Re: Modification to AIDEA AMDIAP SF299 Communications Application Amendment

Exhibit A. Information for BLM SF299 Application Communications Amendment

Figure 1-Fiber Optic Installation

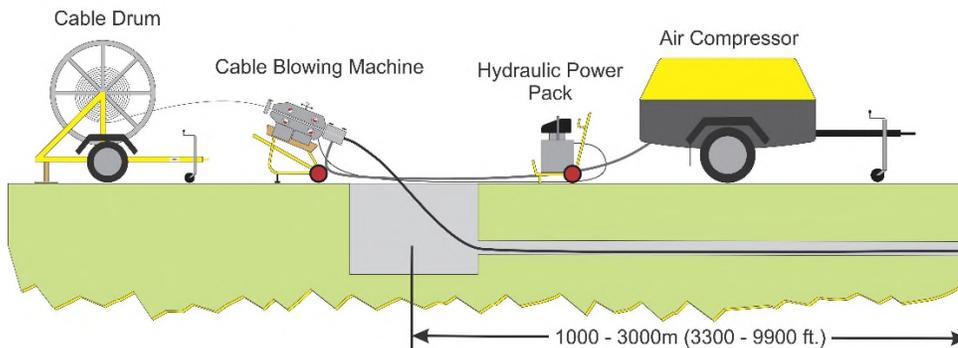
- Describe in detail how the line would be installed, the type of equipment used, and type of vegetation removal.
See Section 7(g) of the SF299 Application Communications Amendment. Equipment used would include a backhoe or small excavator for hand hole construction, a reel trailer for spooling duct and a small jetting machine with an air compressor and a reel trailer with cable drum to spool fiber (below), a boring machine for under river crossings (see below), and a boom truck or crane for communication tower erection.
